REQUEST FOR INFORMATION

RFI NUMBER	NL-RFI-039
ISSUE DATE (YY/MM/DD)	March 24, 2011
PRIORITY	H <input type="checkbox"/> M <input checked="" type="checkbox"/> X <input type="checkbox"/> L <input type="checkbox"/>
REQ'D RESPONSE DATE	March 30, 2011

Hope Bay Mining Project

Subject:	Pollution Pond – HDPE Culvert Boots	Project Zone/Area:	Doris North / Doris
Company:	Nuna Logistics Ltd. (Nuna)	Station/Location:	Sediment & Pollution Ponds
Attention:	Doug Fielding/Jerry Graham cc SRK	Discipline:	Civil

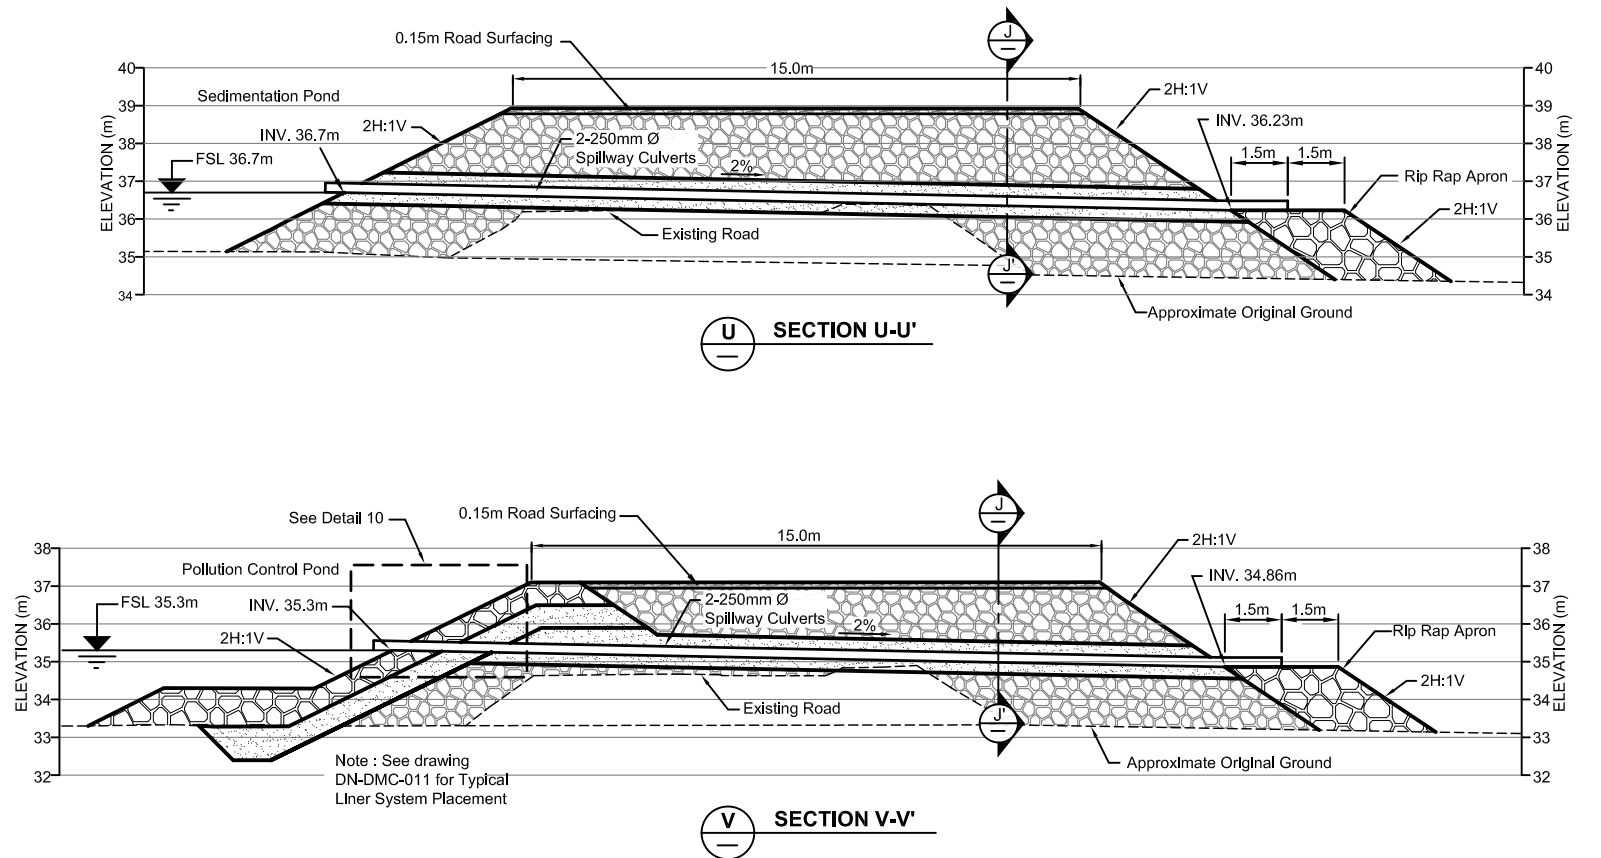
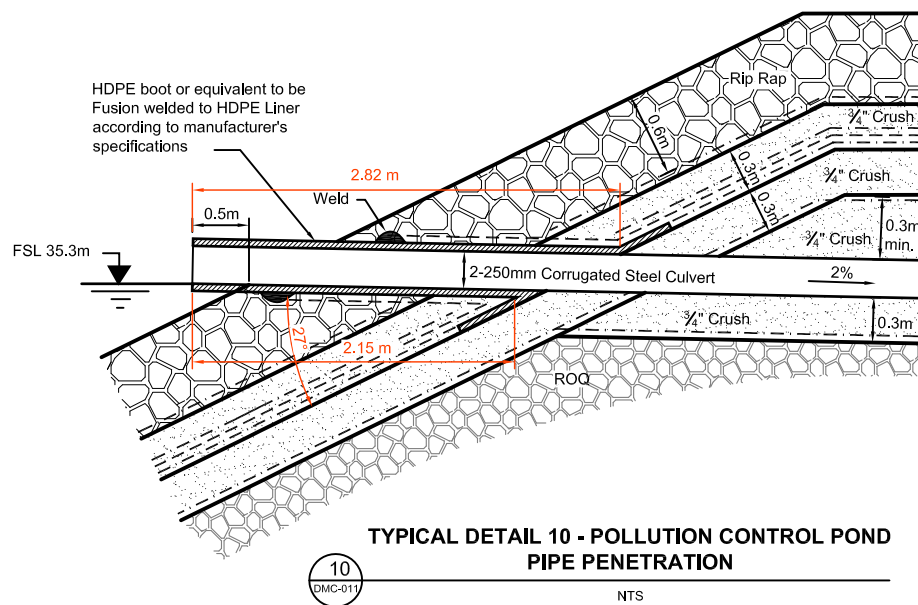
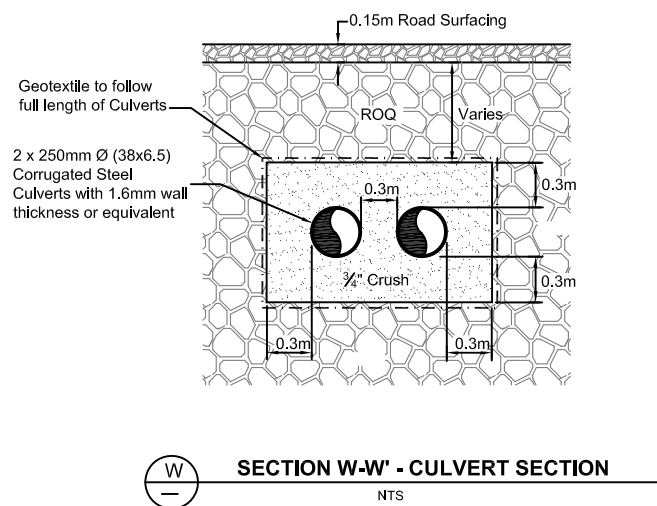
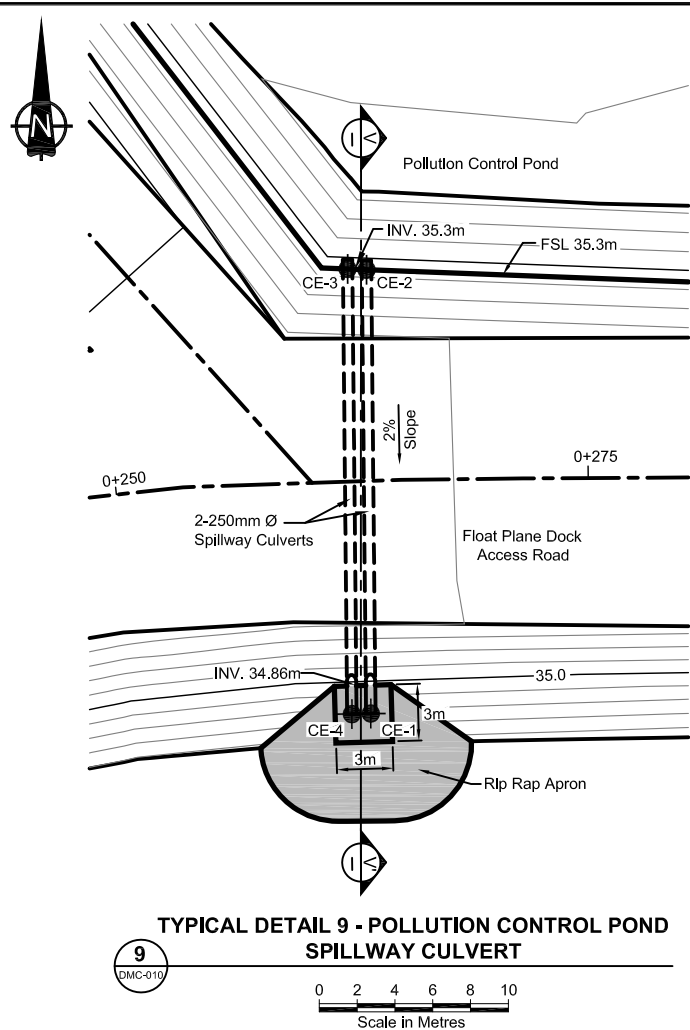
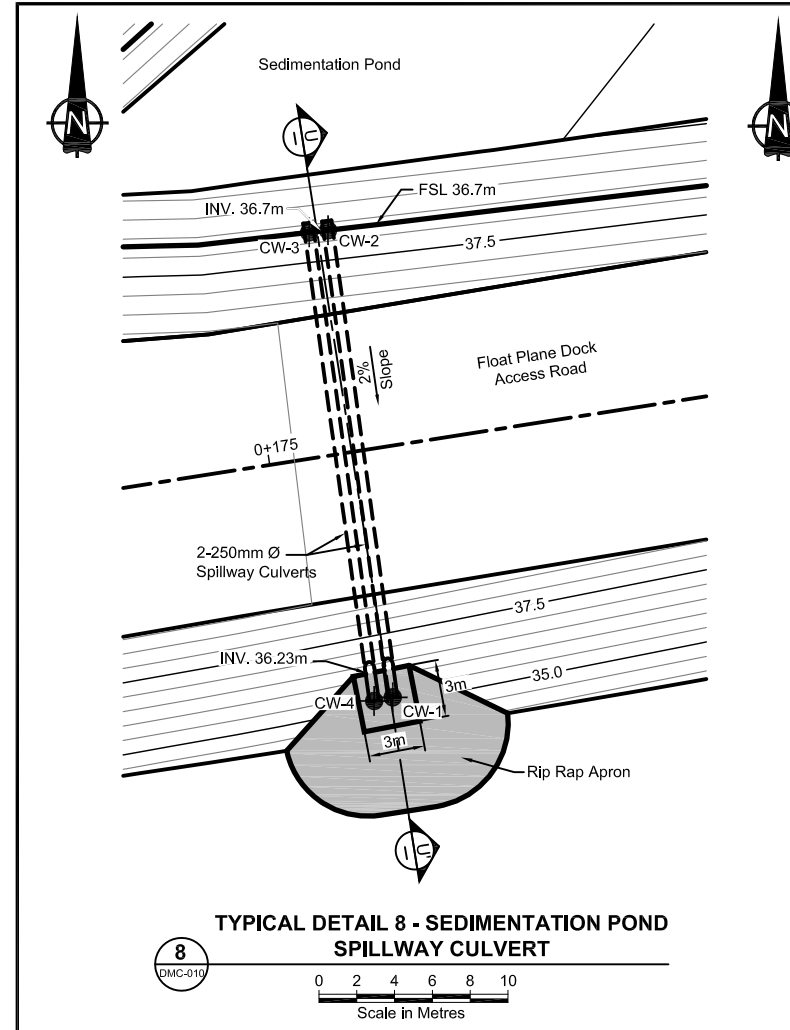
Nuna is requesting the specifications for the HDPE boots that will installed on the culverts for the Pollution Control Pond. Nuna also requests confirmation that only 2 HDPE boots are required for the Sedimentation and Pollution Control Ponds.

SRK to provide Nuna with the dimensions for the HDPE boots (see attached figure) and confirm the number of HDPE boots required.

Please see attached figure (Typical Detail 10 from IFC Drawing DN-DMC-014) for the requested dimensions of the HDPE boots.

Regarding the number of boots required, we can confirm that only 2 (two) boots are needed, as only the pollution Control Pond will be lined.
